UNITED STATES PATENT AND TRADEMARK OFFICE

APPLICATION NO.	FILING DATE	FIRST NAMED INVENTOR	ATTORNEY DOCKET NO.	CONFIRMATION NO.
09/925,343	08/09/2001	Gerd Jakob Ernst Scheller	CH 000016	4400

Office Action Summary

DETAILED ACTION

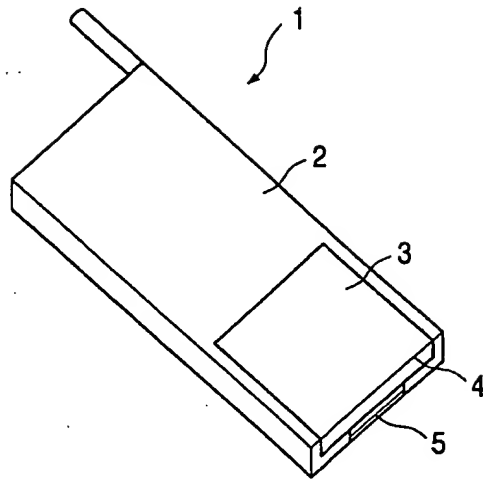
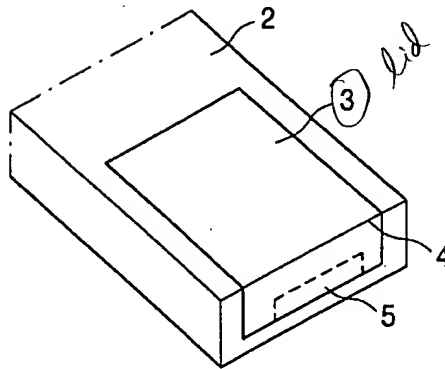
5. The drawings are objected to under 37 CFR 1.83(a) because they fail to show a legend describing the labels on the Figures as described in the specification. Any structural detail that is essential for a proper understanding of the disclosed invention should be shown in the drawing. MPEP § 608.02(d). Corrected drawing sheets in compliance with 37 CFR 1.121(d) are required

legend problem
